**REGULAR MEETING OF THE THIRD LAGUNA HILLS MUTUAL
ARCHITECTURAL CONTROL AND STANDARDS COMMITTEE**

**Monday, June 25, 2018 – 9:30 a.m.
Laguna Woods Village Community Center Sycamore Room
24351 El Toro Road**

DATE: June 25, 2018
FOR: Architectural Control and Standards Committee
SUBJECT: Variance Request
Ms. Yu-Hsiung Chen of 3142-A (Las Flores, PL203C, 42)
Room Addition on Back Patio

DATE: June 25, 2018
FOR: Architectural Control and Standards Committee
SUBJECT: Variance Request - Mr. Michael Epstein of 3235-C (La Reina, SB703R_B, 43R) Replace Enclosed Patio with Room Addition

LA REINA (43 PLAN)

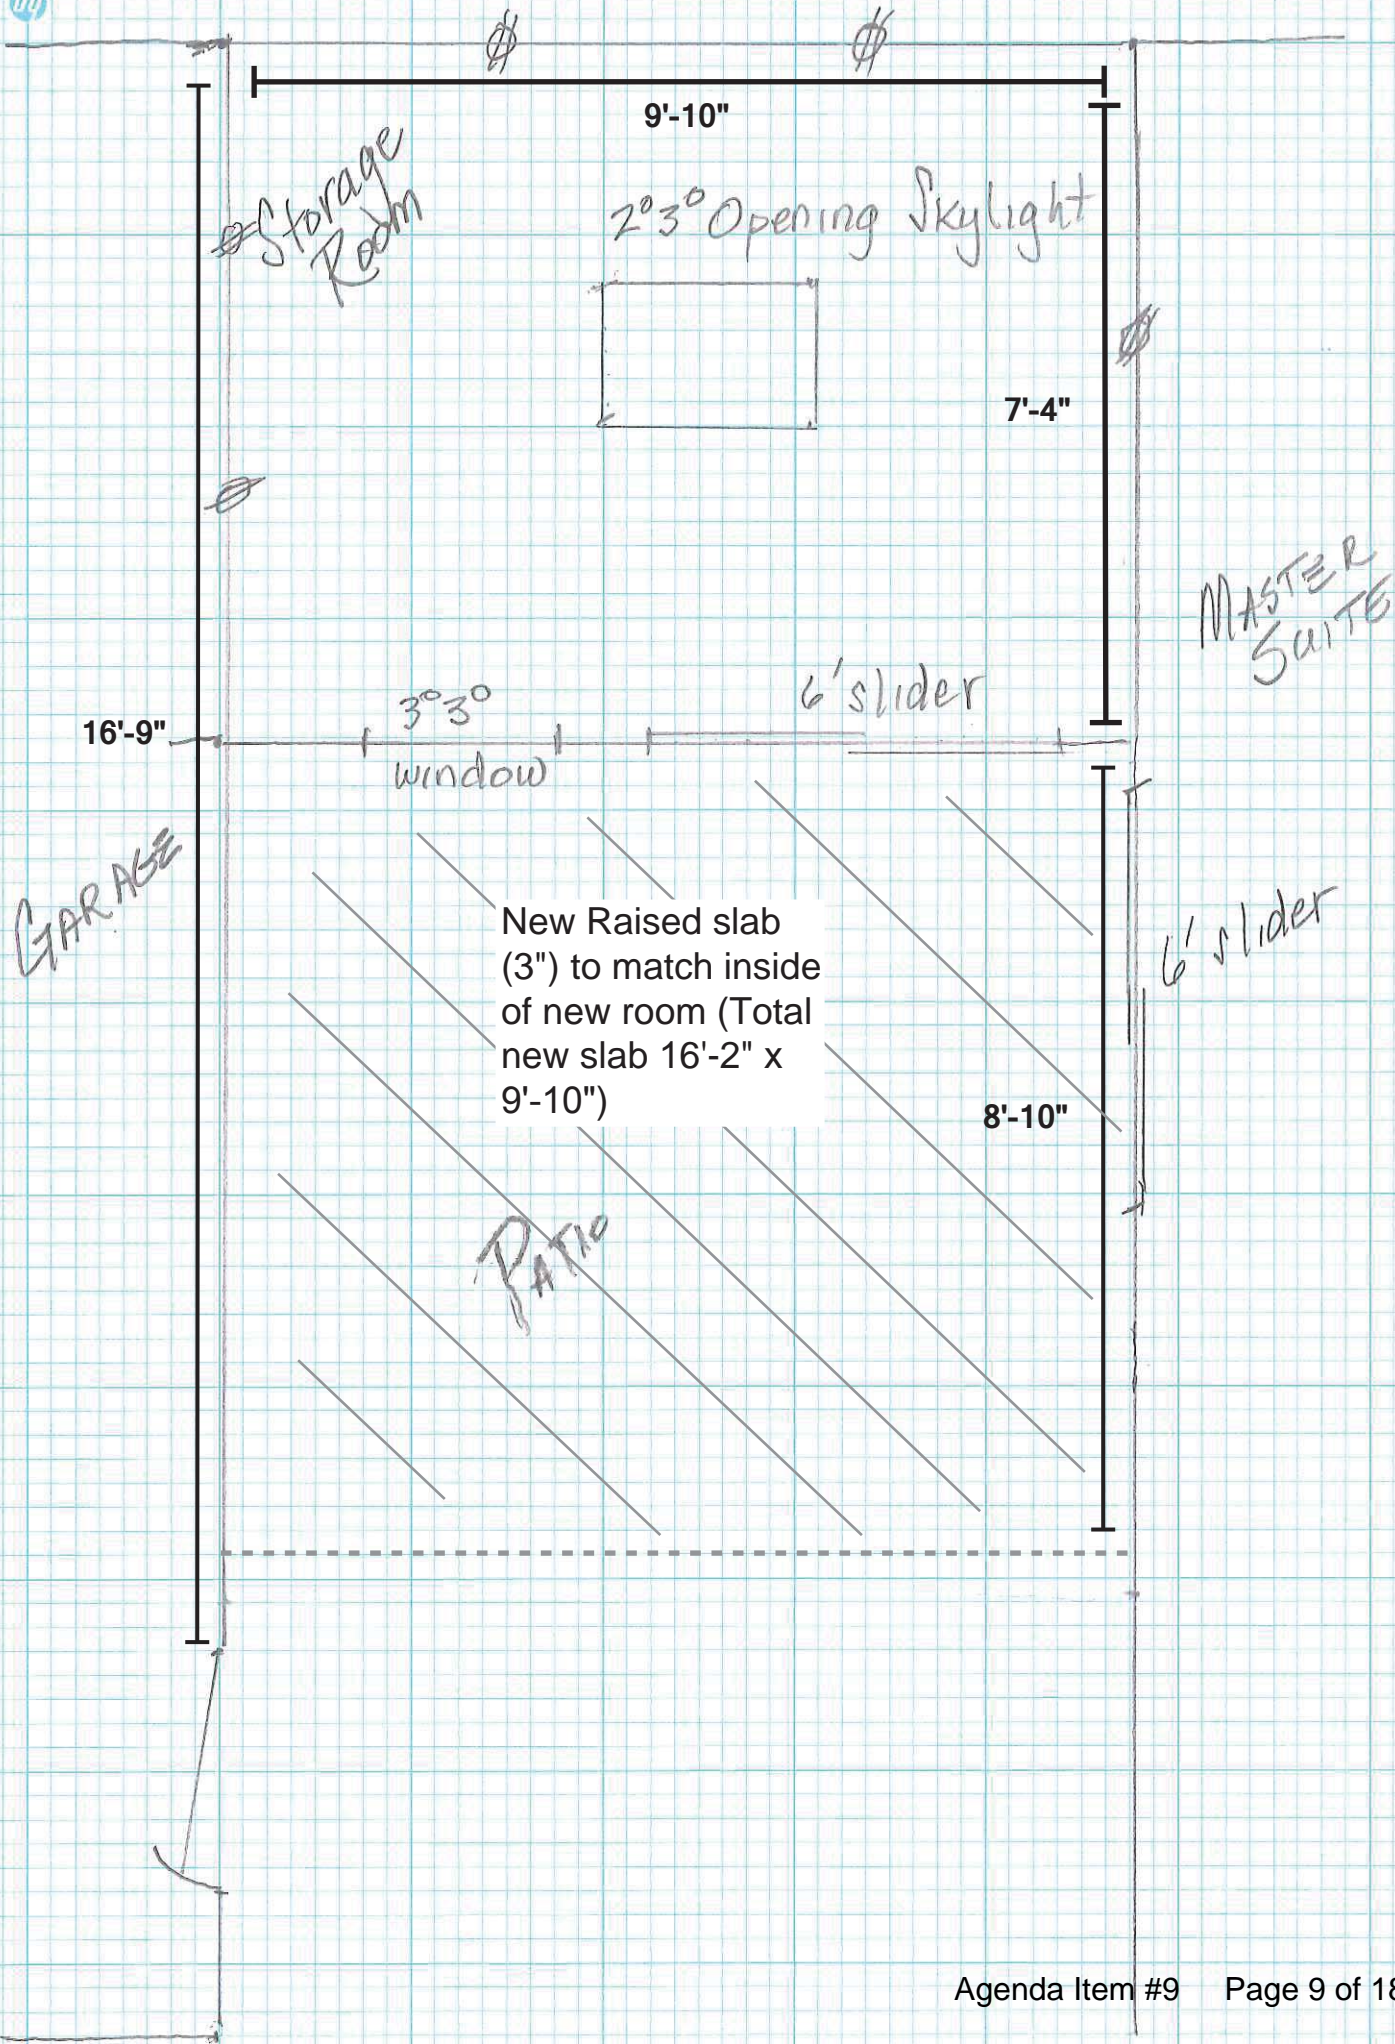
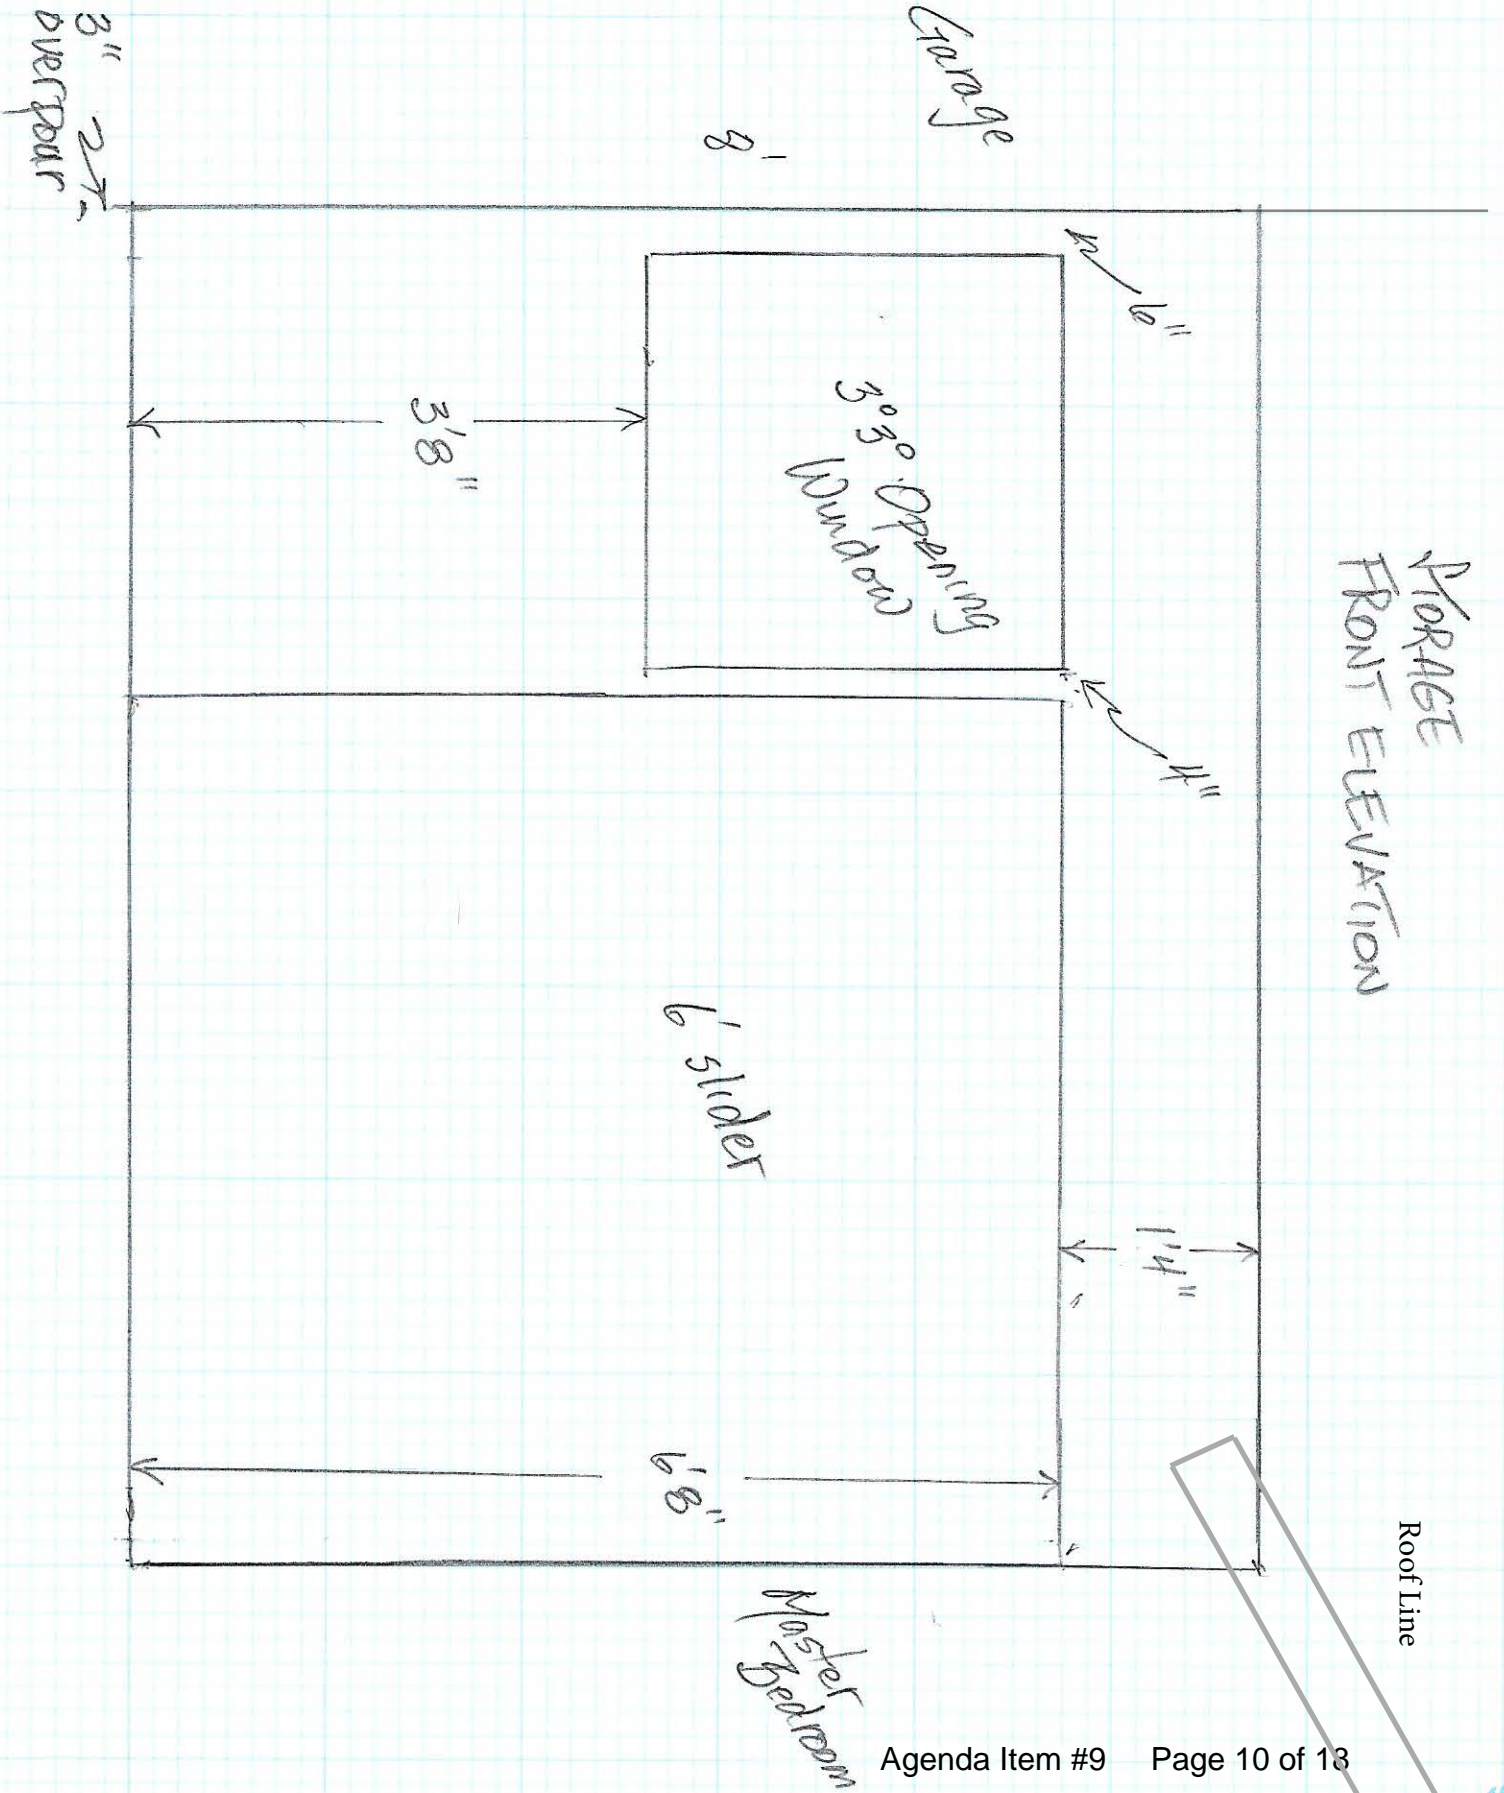
Mr. Epstein proposes to use Standard Plan 300 as a basis to add a room addition measuring 7'4" wide by 9'10" long on the front patio using wood frame and stucco to match the existing building exterior.

The proposal calls to remove the existing patio enclosure (16'2" wide by 9'10" long), including the existing master bedroom sliding glass door. The existing door opening width would be reduced from 8' wide to 6' wide; the existing height would remain at 6'8" tall. The remaining 2' space would be filled in with drywall and stucco to match the rest of the wall.

Staff recommends the Board approve the request to replace the enclosed patio with room addition with the conditions stated in Appendix A.
